STAFF'S  
REQUEST ANALYSIS  
AND  
RECOMMENDATION

08TS0105

Old Gun Road Properties and Tony and Kathryn Lucas  
(The Preserve At Old Gun)

REQUEST: Tentative Subdivision plat approval of twenty (20) single-family lots in addition to relief from street connectivity requirements.

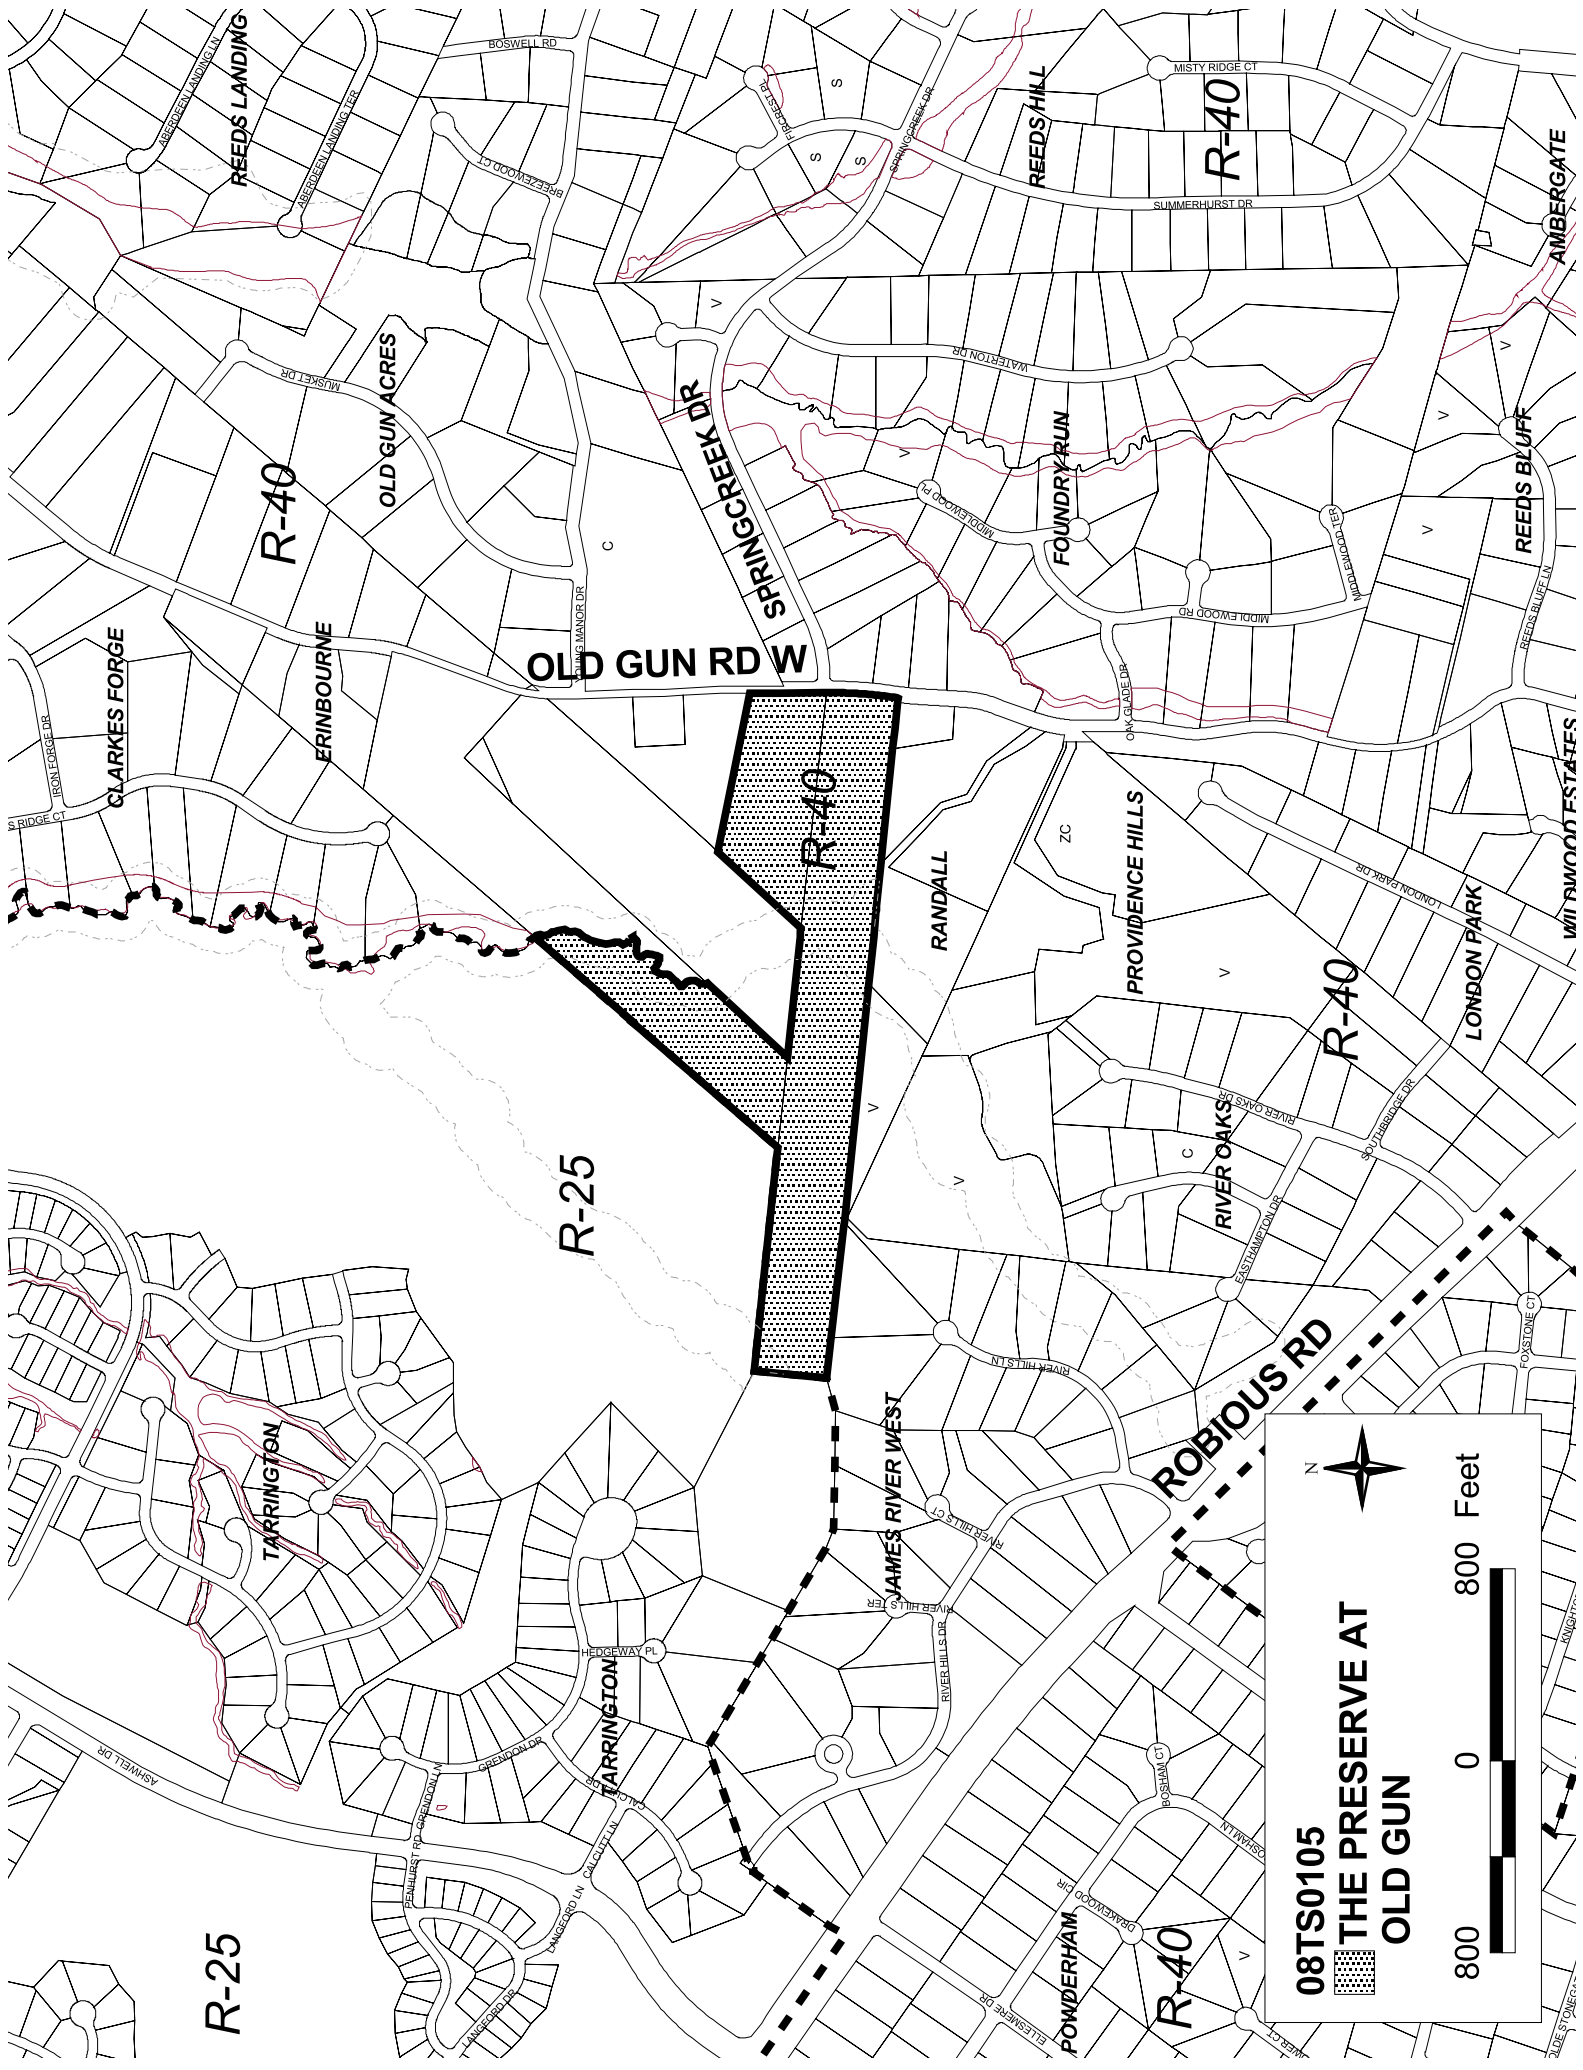
Within this case staff requested the alignment of Capwell Drive to be located along the northern boundary adjacent to the Greer Tract (GPIN 736-722-6328) to the north of this case. This tract has a wetland feature that separates the property at it's southern edge leaving a little more than one (1) acre of upland developable space separated by 100 foot Resource Protection Area (RPA) on either side of the wetlands. Future access to this upland area could be provided with a simple drive way cut to Capwell Drive, thus eliminating the need to impact the wetlands on the Greer property with crossing the wetlands for access. The applicant has instead shifted Capwell Drive to the south, in so doing leaving a "spike" strip within this development along the entire length of the Greer property ranging from approximately five (5) feet wide to as much as twenty-five (25) feet wide. This strip would be left in open space, thereby giving control of that land to a Homeowners Association (HOA) which would be established by Ordinance. (Attachment 2)

Additionally, staff requested one (1) stub road be provided to the landlocked McHugh tract (GPIN 735-720-3696) adjacent to the south and the applicant has refused. Ordinance standards would not permit development of the tract without achieving a minimum fifty (50) foot of improved road frontage, or an applicant would have to receive approval of a Variance from the Board of Zoning Appeals to develop without improved access to this parcel. The provision of a stub road to this parcel would not only provide access, but additionally encourage connection to adjacent tracts should development progress to the south in the future. The stub road would not

(Previously approved tentative with ROW alignment and approved stub roads)

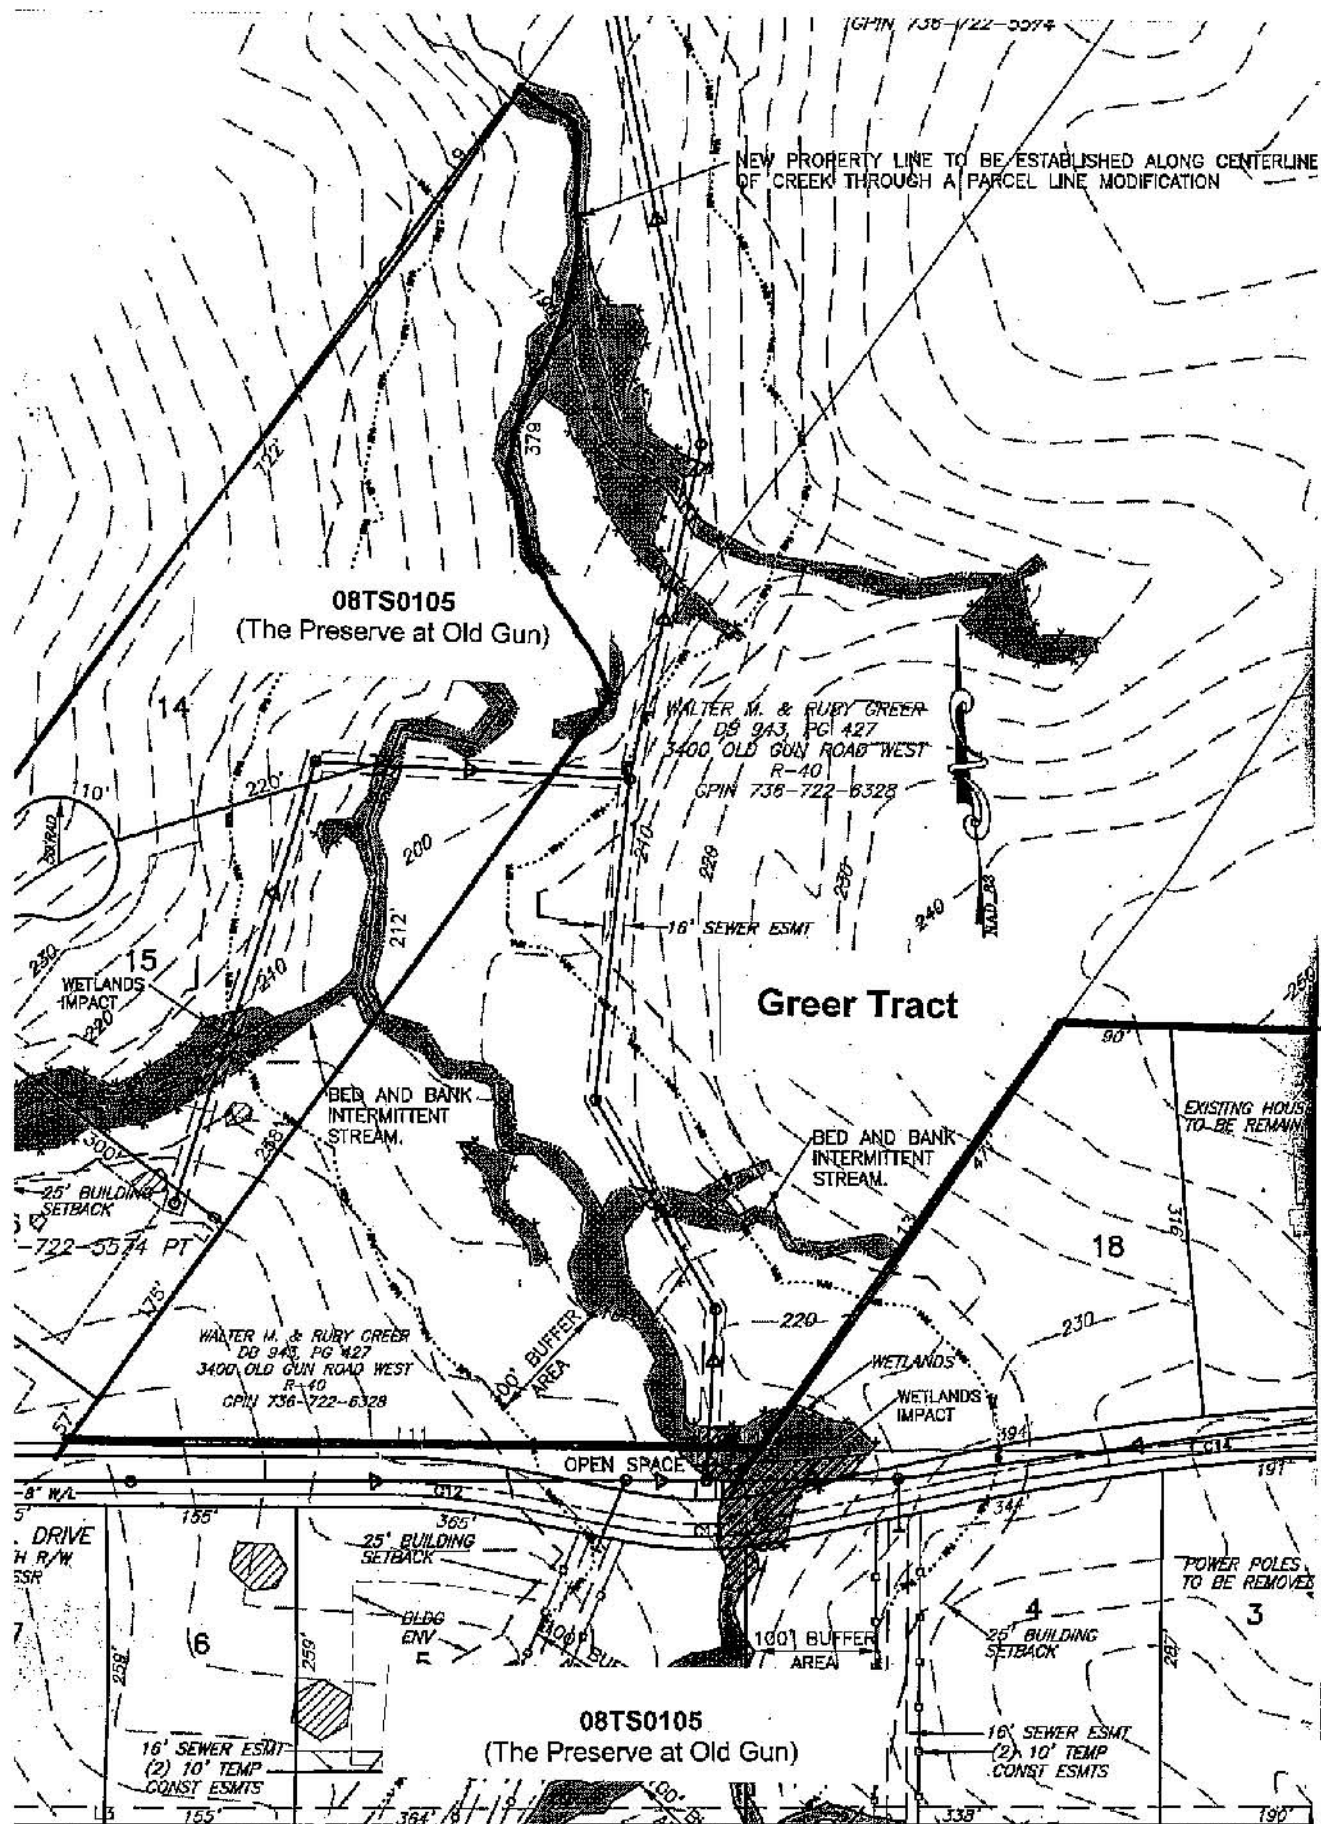
On July 18, 2006, the Planning Commission reviewed and approved Case 05TS0196 (The Battery at Old Gun) which was a tentative with nineteen (19) lots containing three (3) parcels of land (Attachment 1). The Planning Commission approval included conditions for the provision of two (2) stub roads within the development to adjacent parcels of land to the south. Additionally, the alignment of the residential road was to be located along the northern edge of the tentative property line to provide access to the Ruby Greer tract (GPIN 736-722-6328) (Attachment 1). These conditions allowed for orderly development and efficient interconnectivity to this development and adjacent tracts to the north and south, thereby reducing the future number average Daily Trips along Old Gun Road. Subsequent to this tentative approval, the County did not approve construction plans or record any plats within the limits of this case.
